## ELSA-Draft UNECE R100

**UNIFORM PROVISIONS CONCERNING THE APPROVAL OF VEHICLES WITH REGARD TO SPECIFIC REQUIREMENTS FOR THE ELECTRIC POWER TRAIN**

**Comment [VR1]:** Modified from ECE R100

Table 1  
Access probes for the tests for protection of persons against access to hazardous parts

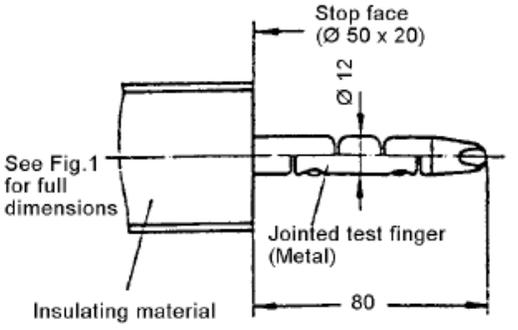
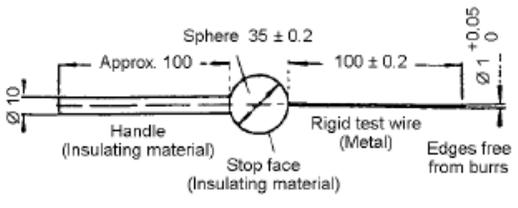
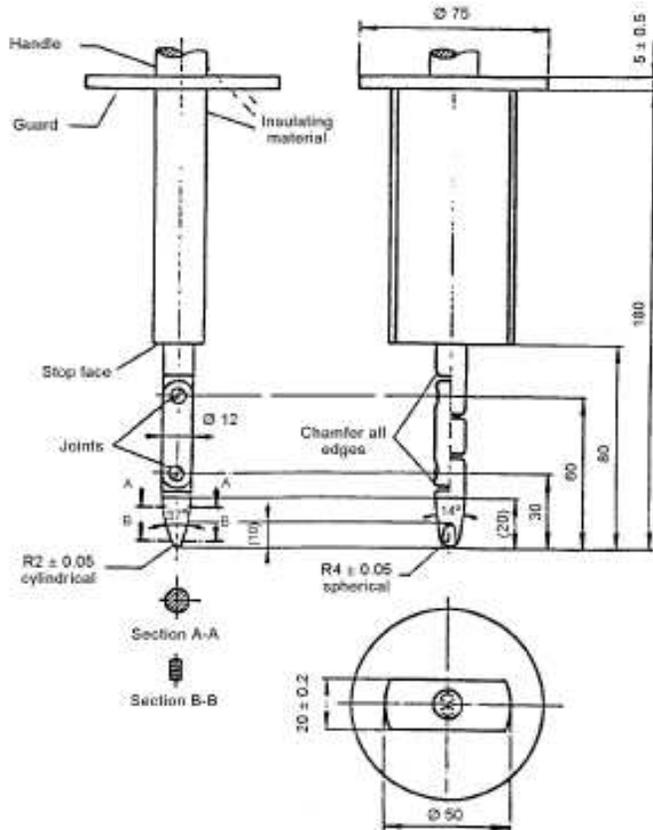
**Comment [VR20]:** Modified R100 Annex, content taken from ELSA in use draft,

Figure 1: Measurement of  $V_b$ ,  $V_1$ ,  $V_2$

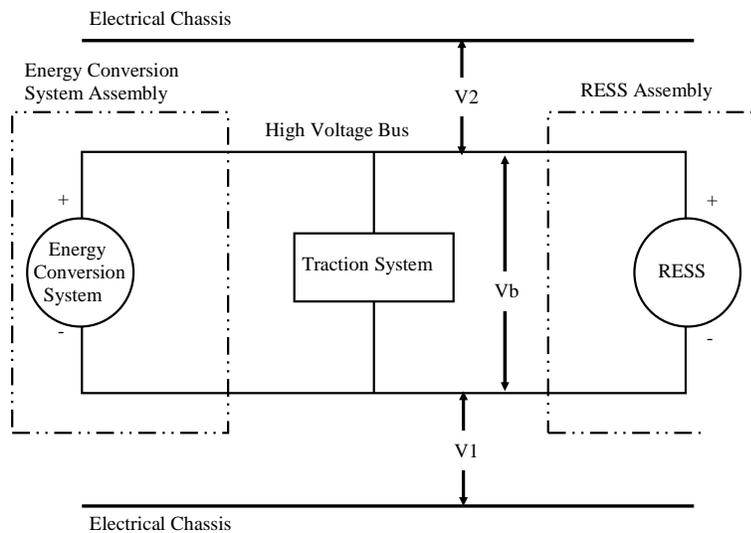
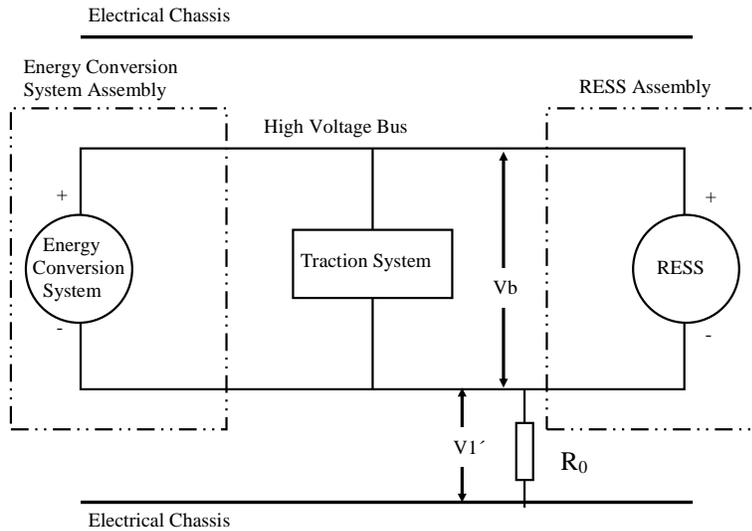
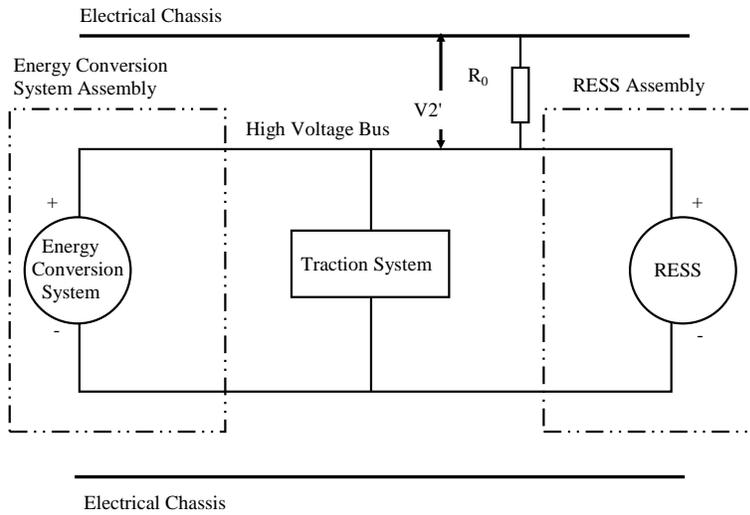
**Comment [VR21]:** Modified R100 Annex, content taken from ELSA in use draft,
